UNITED STATES PATENT AND TRADEMARK OFFICE

APPLICATION NO.	FILING DATE	FIRST NAMED INVENTOR	ATTORNEY DOCKET NO.	CONFIRMATION NO.
09/745,468	12/26/2000	Naoki Tsuji	49657-862	1840

Office Action Summary

Claim Rejections - 35 USC § 103

FIG. 21B

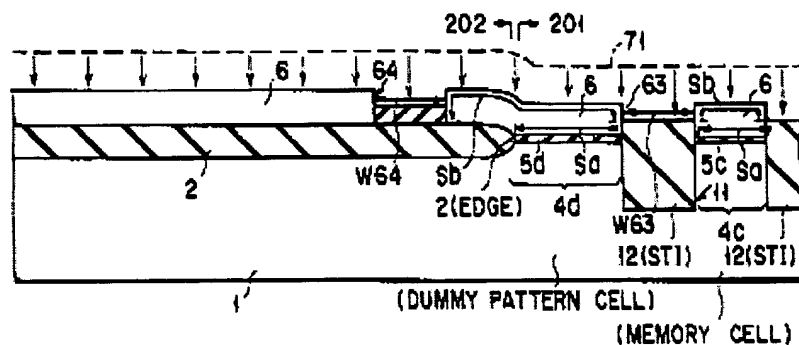
Trench isolation patterns (Shimizu fig. 21 b # 12 (STI), and extending continuously in a first direction (Shimizu Fig. 21 B #12 extending continuously in at least the lateral and/or vertical directions) .

With respect to claim 11, to the extent understood, Shimizu describes a semiconductor device wherein the pattern of the dummy trench isolation extends in a vertical direction with respect to the first direction. (See fig. 21 b # 12 (STI), reproduced below and extending in vertical direction) .
